RMS Ref: SYD12/00063/02
Department's Ref: MP08_0222 (MOD3)

**SECTION 75W MODIFICATION - GLOBAL SWITCH SYDNEY EAST PROJECT AT 273
PYRMONT STREET, ULTIMO**

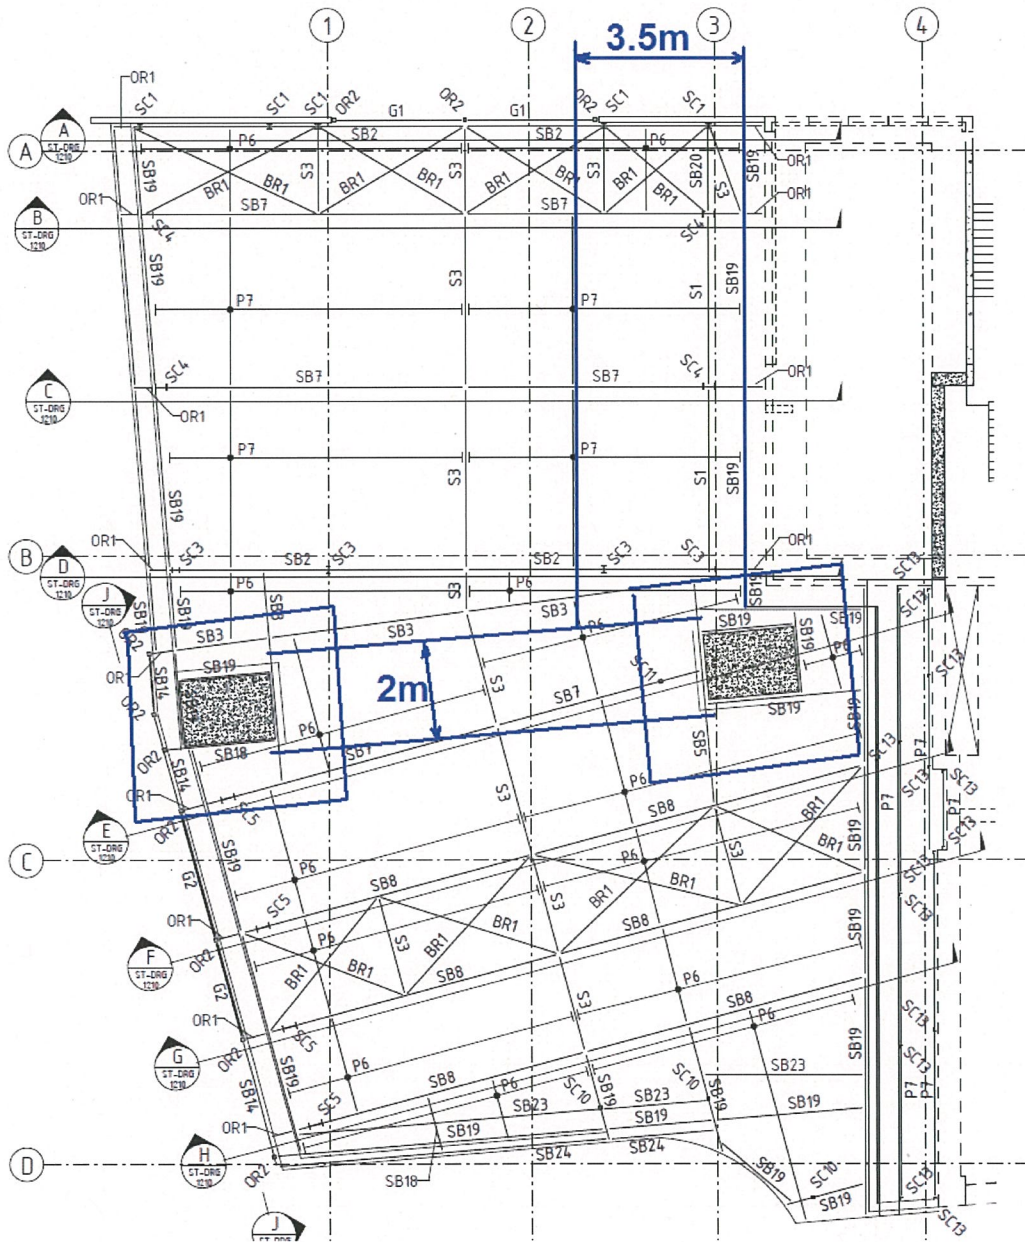
8. In order for RMS to carry out inspections, maintenance and rehabilitation works on the bridge piers a 3.5m width access from Pymont St to at least one bridge pier and a 2m width clearance between the two piers is required. These clearances needs to be accessible 24 hours a day to enable emergency works to be carried out as required.

Included is a diagram showing a possible arrangement, to pictorially show these requirements:
